SUBJECT: Application for amends to Licenses DPR-58 & DPR-74, changing Westinghouse fuel & reload analysis methodology.

Donald C. Cook Nuclear Plant Units 1 and 2
Docket Nos. 50-315 and 50-316
License Nos. DPR-58 and DPR-74
UNIT NO. 2 CYCLE 8 RELOAD LICENSING, PROPOSED TECHNICAL
SPECIFICATIONS FOR UNIT 2 CYCLE 8, AND RELATED
UNIT 1 PROPOSALS

SAFETY EVALUATION
FOR THE
DONALD C. COOK NUCLEAR PLANT UNIT 2
TRANSITION TO WESTINGHOUSE 17X17 VANTAGE 5 FUEL

Figure 2.1-1 Reactor Core Safety Limits
Four Loops in Operation

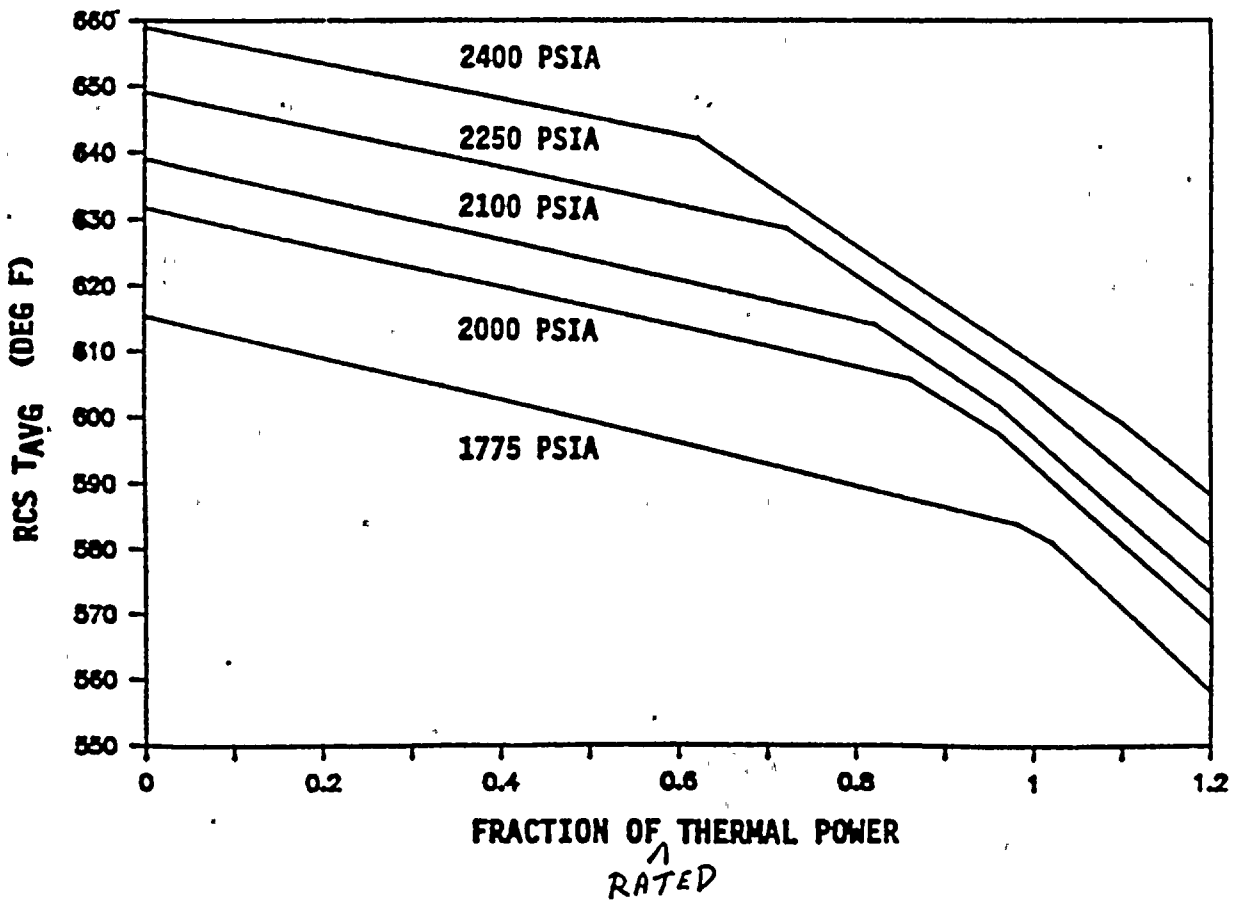
<u>SECTION, PAGE</u>	<u>CHANGE</u>	<u>REASON FOR CHANGE</u>
1.0, pg I	Add COLR to index	COLR implementation
1.12a, pg 1-3	Add COLR	COLR implementation
Figure 2.1-1, pg 2-2	Revised safety limits	Reanalysis supports VANTAGE 5 reload

- a) Reactor Core Safety Limit Curves and OTdelta-T/OPdelta-T Reactor Trip Setpoints, T/S Figure 2.1-1 and T/S Table 2.2-1, Functional Units 7 and 8.

FIGURE 3.1-3 REQUIRED SHUTDOWN MARGIN

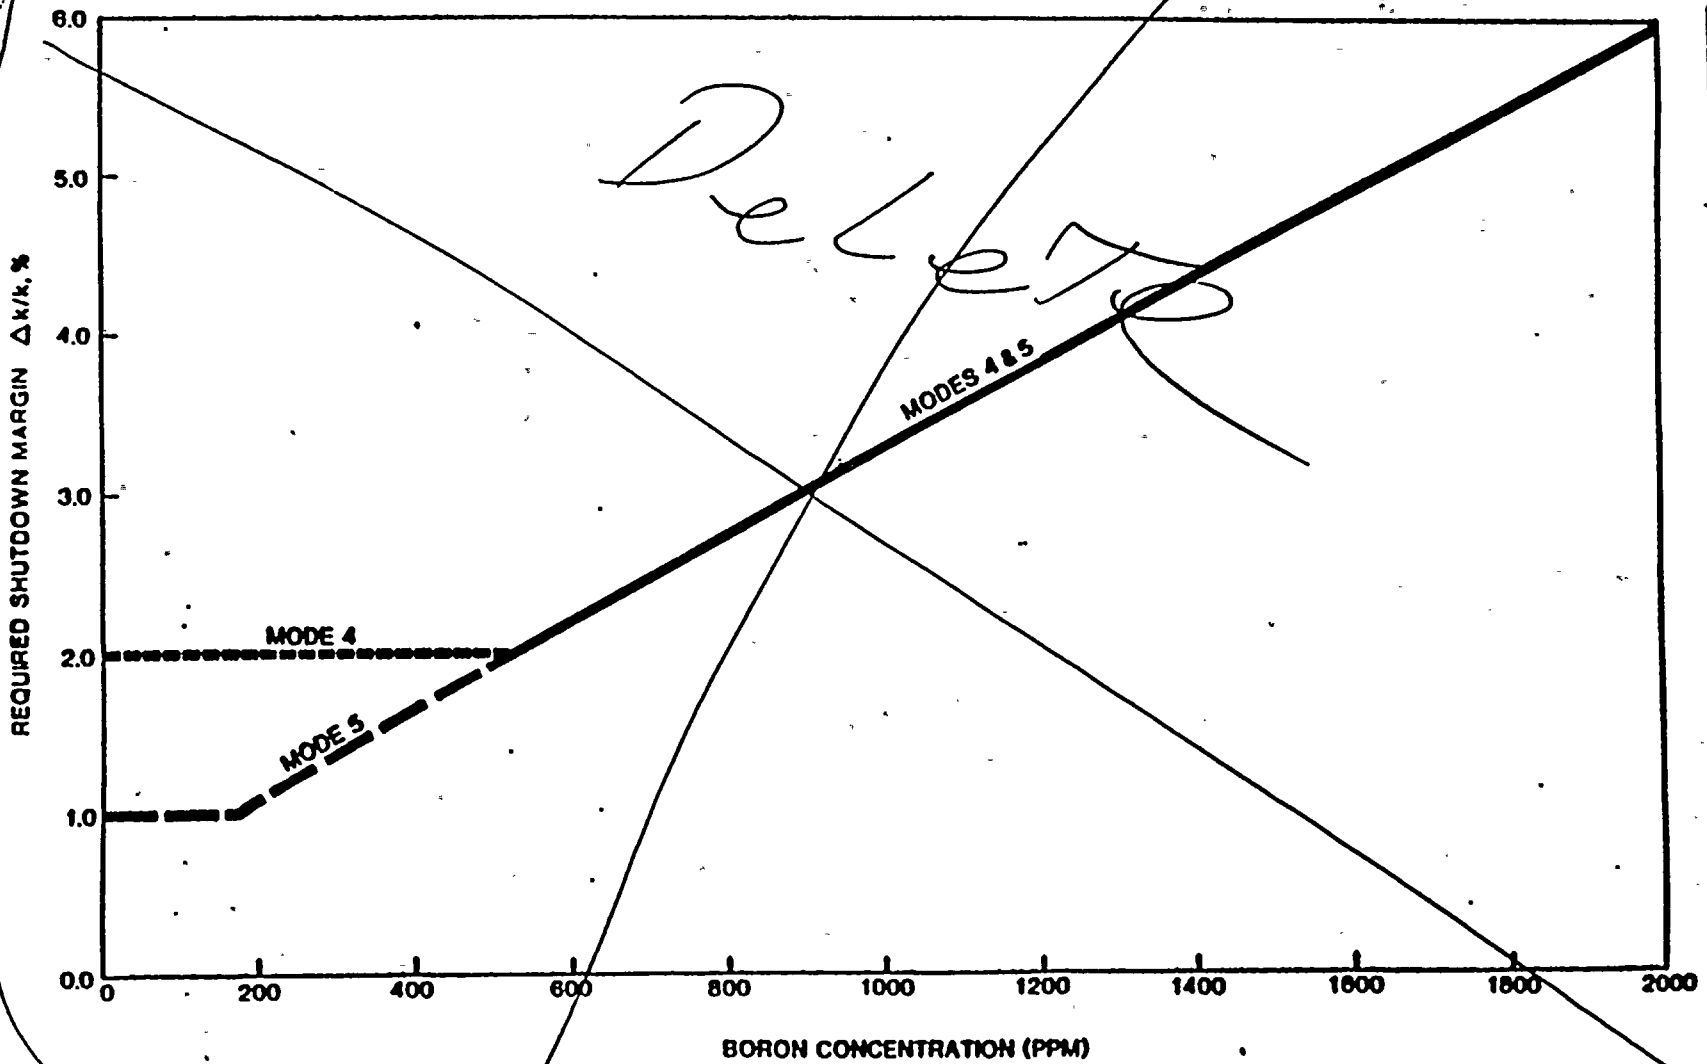
These changes are numbered 027, 032 and 033 in Attachment 3. AEP proposes to rearrange T/Ss 3/4.1.1.1 and 3/4.1.1.2 into STS format by moving the Mode 4 requirement from 3.1.1.2 to 3.1.1.1 and deleting Figure 3.1-3 and related references. In the Cycle 6 submittal the Mode 4 shutdown margin was moved from 3/4.1.1.1 to 3/4.1.1.2. The Cycle 6 change to T/S 3/4.1.1.2, which then included Mode 4 and Mode 5 in the same T/S, was a revision that reflected the results of the boron dilution accident analysis when heat removal is via the residual heat removal (RHR) system. This analysis was performed by ANF.

Figure 3.1-1
ROD BANK INSERTION LIMITS VERSUS THERMAL POWER
FOUR LOOP OPERATION

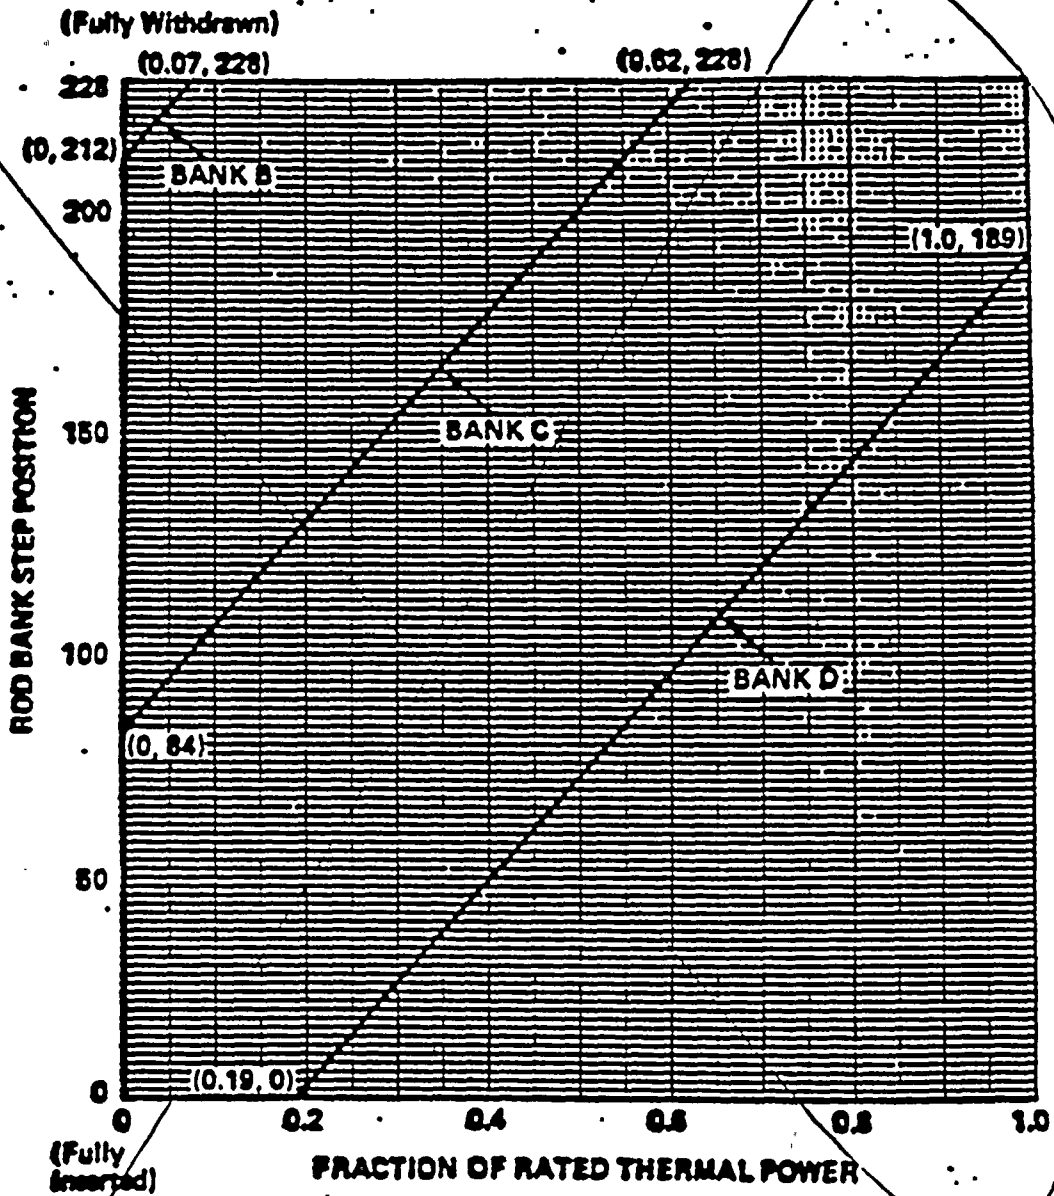
3.1.3.6 The control banks shall be limited in physical insertion as shown in Figure 3.1-1. SPECIFIED IN THE CORE OPERATING LIMITS REPORT (COLR)

DELETE THIS PAGE

<u>SECTION, PAGE</u>	<u>CHANGE</u>	<u>REASON FOR CHANGE</u>
3/4.1.3.6, pg 3/4 1-25	Relocate control rod insertion limits to COLR	COLR implementation (relocation of control rod insertion limits)
3/4.1.3.6, pg 3/4 1-26	Delete figure 3.1-1	COLR implementation
3/4.3.2.1, pg 3/4 2-1 & 2-3	Relocate axial flux difference limits to COLR	COLR implementation (relocation of AFD limits)
3/4.3.2.1, pg 3/4 2-4	Relocate axial flux difference allowable deviation Fig. to COLR	COLR implementation (relocation of AFD allowable deviation)
3/4.3.2.2, pg 3/4 2-5	Relocate F_Q limits to COLR	COLR implementation (relocation of F_Q limit)
3/4.3.2.2, pg 3/4 2-8, 2-8a & 2-8b	Relocate $K(Z)$ & $V(Z)$ figures to COLR	COLR implementation (relocation of F_Q limit)
3/4.3.2.3, pg 3/4 2-9	Relocate $F_{\Delta H}^N$ limits to COLR	COLR implementation (relocation of $F_{\Delta H}^N$ limit)
3/4.2.5.1, pg 3/4 2-15	Reformat DNB spec Change DNB parameter values and add low Tav _g window	Adopt planned Cook Nuclear Plant Unit 1 spec format consistent with VANTAGE 5 reload

FIGURE 3.2-1 ALLOWABLE DEVIATION FROM TARGET FLUX DIFFERENCE

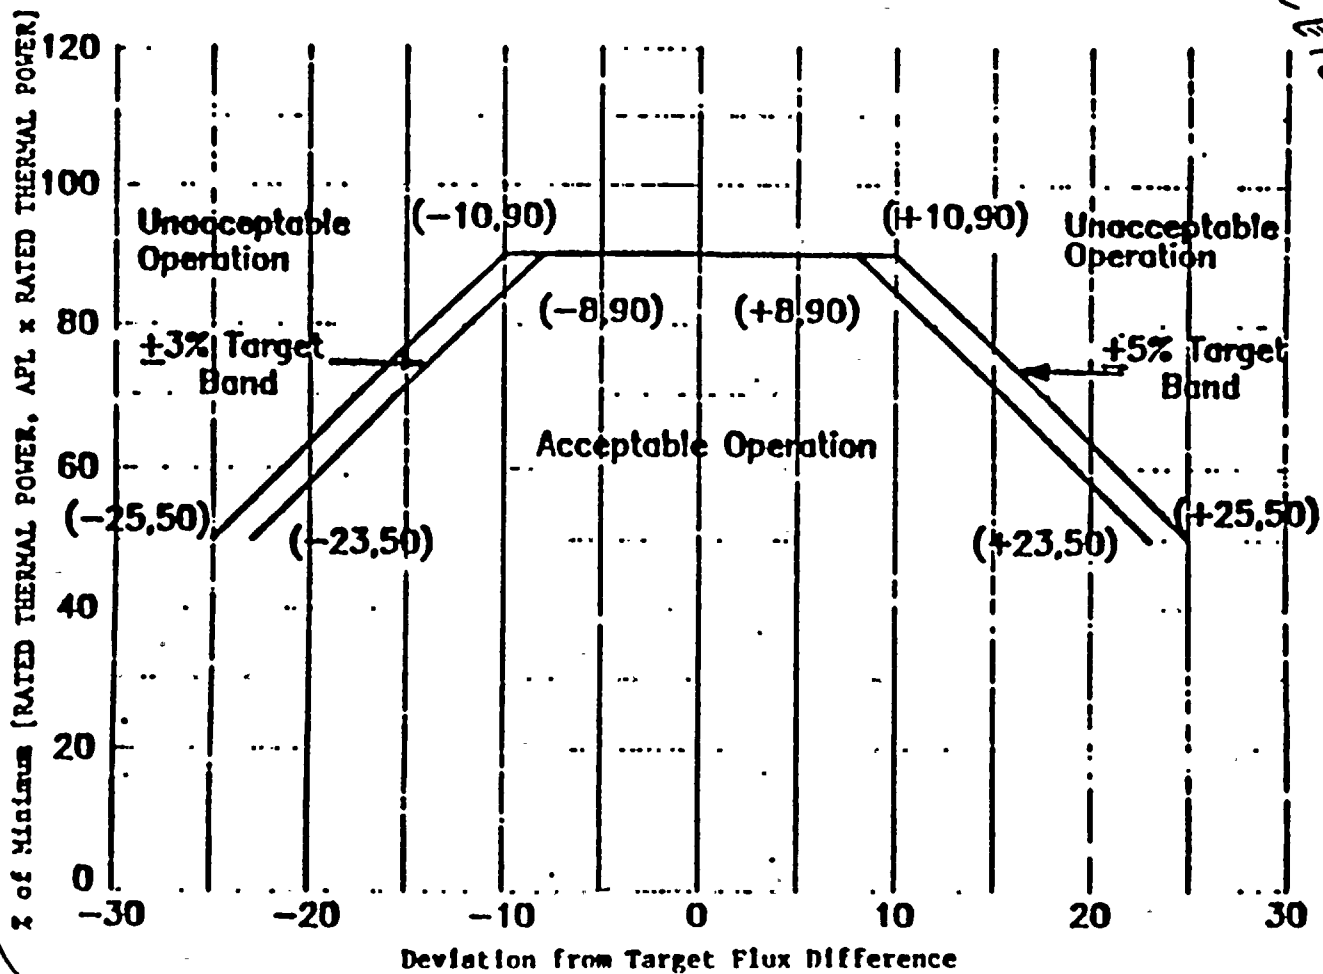
2) The indicated AFD is within the limits *Specified in The COLR* ~~shown on Figure 3-2-1~~. Otherwise, reduce THERMAL POWER to less than 50% of RATED THERMAL POWER within 30 minutes and reduce the Power Range Neutron Flux-High Trip Setpoints to less than or equal to 55% of RATED THERMAL POWER within the next 4 hours.

Figure 3.2-3 V(Z) As A Function of Core Height.

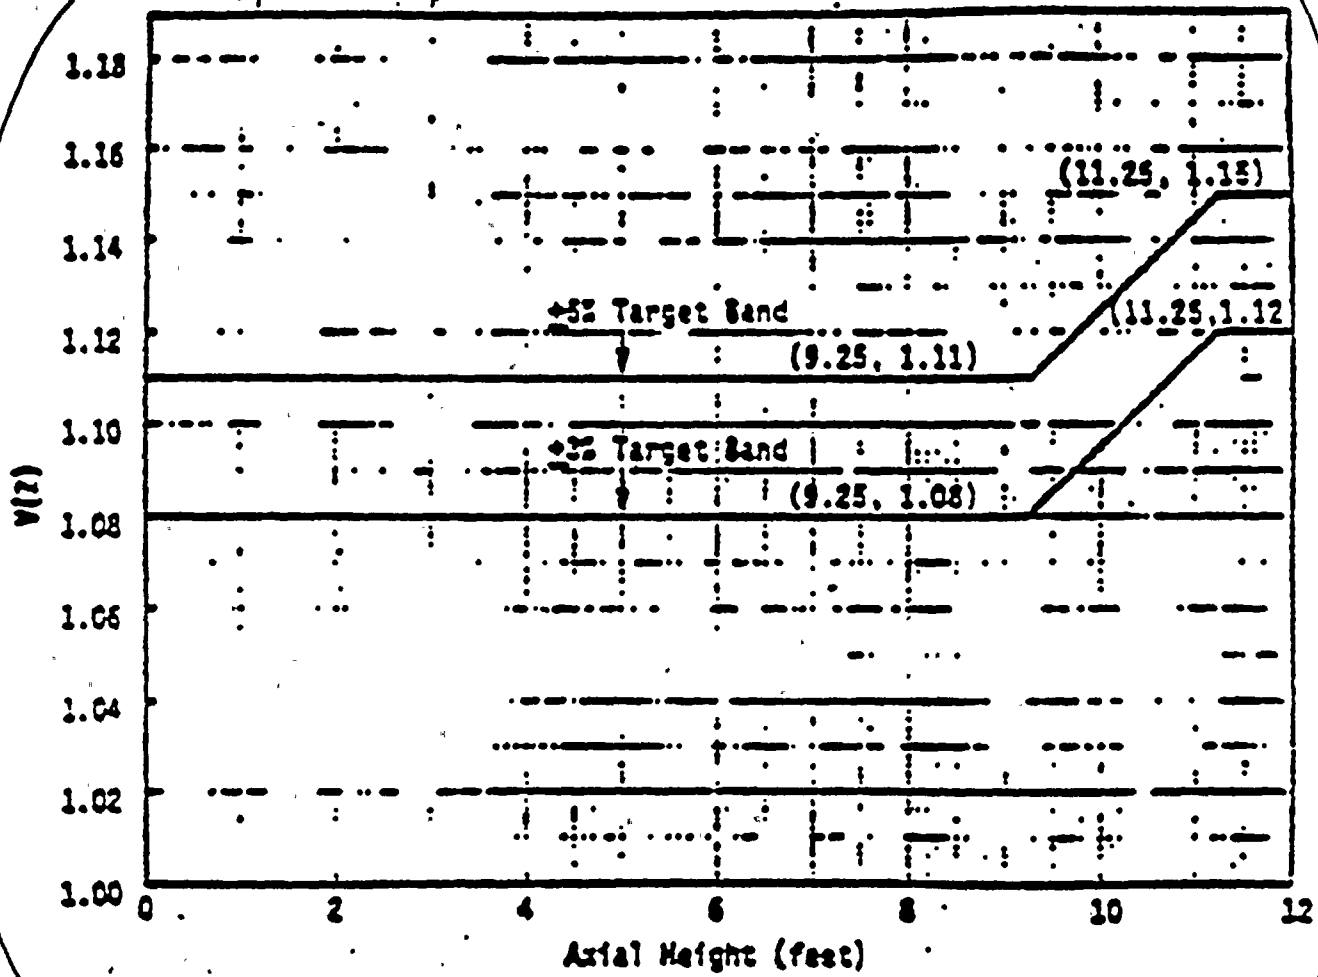
DELETE This PAGE

- $F_Q(Z)$ is the measured hot channel factor, including a 3% manufacturing tolerance uncertainty and a 5% measurement uncertainty.
- $V(Z)$ is the function defined in The COLR, Figure 3.2-3 which corresponds to the target band.
- $F_p = 1.00$ except when successive steady-state power distribution maps indicate an increase in peak pin power, with exposure. Then either of the following penalties, F_p , shall be taken:

FIGURE B 3/4 2-2 ILLUSTRATIVE EXAMPLE OF F_{AH}^N LIMIT VERSUS PERCENT THERMAL POWER FOR EXXON FUEL

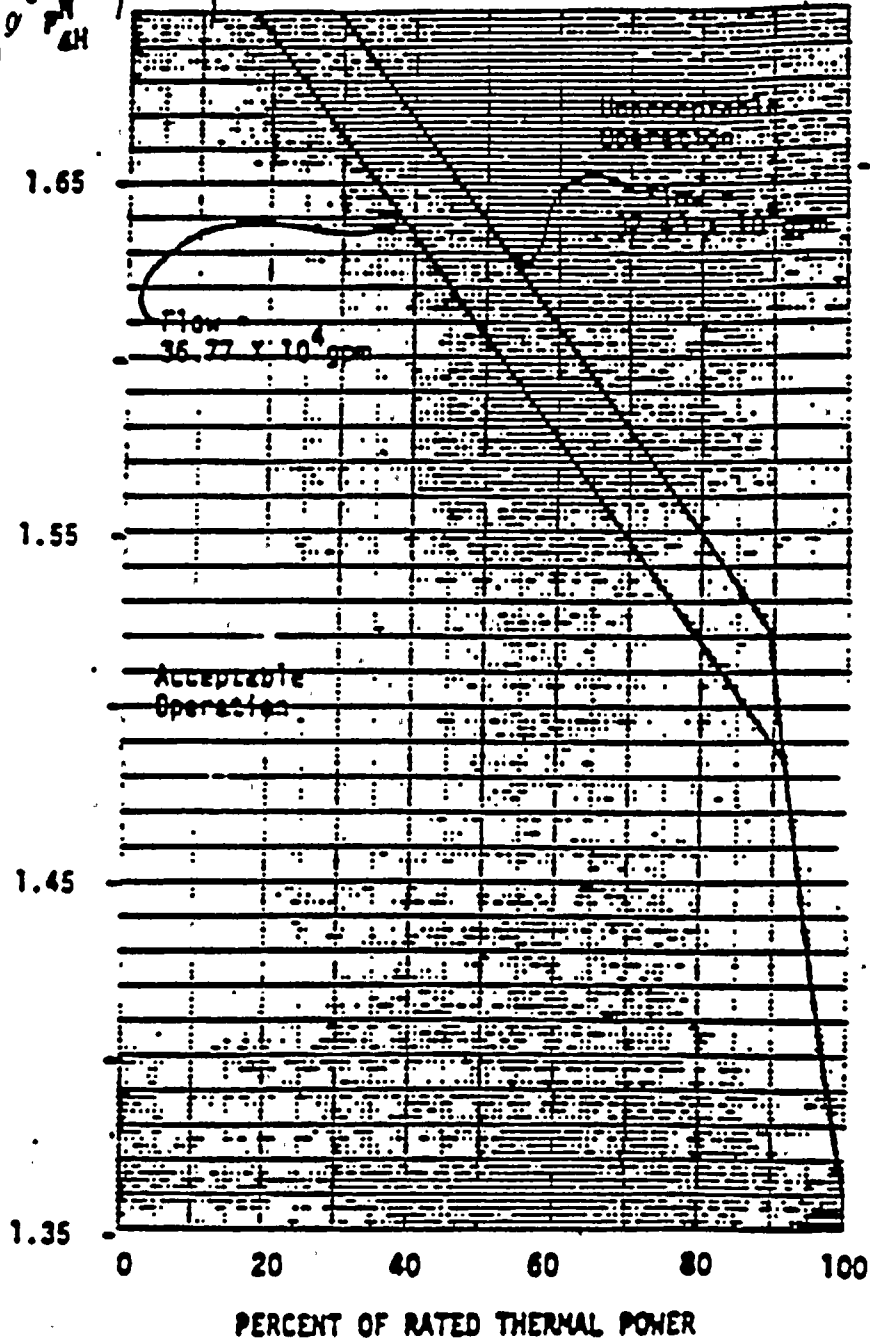
Figure B 3/4 2-2 displays two limiting DNBR $F_{\Delta H}^N$ curves for Exxon Nuclear Company fuel for flows of 36.77×10^6 gpm, and 37.63×10^6 gpm. Also displayed on Figure B 3/4 2-2 is the limit on $F_{\Delta H}^N$ which results from the LOCA analysis for Exxon Nuclear Company fuel. $F_{\Delta H}^N$ must be maintained below and to the left of both the applicable DNBR $F_{\Delta H}^N$ limit and the LOCA $F_{\Delta H}^N$ limit.

DELETE THIS PAGE
